49 CFR Part 571

[Docket No. NHTSA-2010-0021]

Federal Motor Vehicle Safety Standards; Electric-Powered Vehicles; Electrolyte Spillage and Electrical Shock Protection

ACTION: Final rule.

Figure 1. S7.6.3 and S7.7 Measurement of Voltage Source Voltage

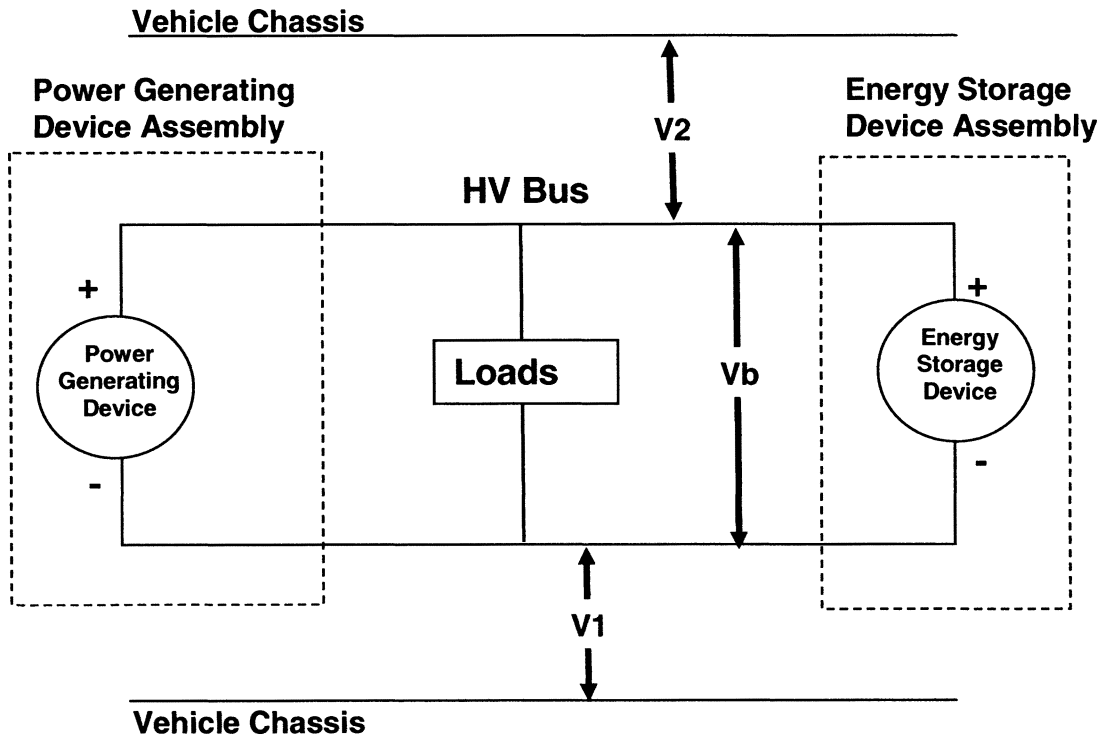
- Minor editorial corrections have been made to other parts of the regulatory text and to Figures 1 through 5.

And fifth, the Alliance/AIAM suggested the following editorial corrections: Figure 1 should refer to S7.6.3, not S7.6.6; in Figure 4, V1 should be V1', and the denominator should be V1'; and in Figure 5, the denominator should be V2'.

We agree with these corrections and have revised the regulatory text accordingly.
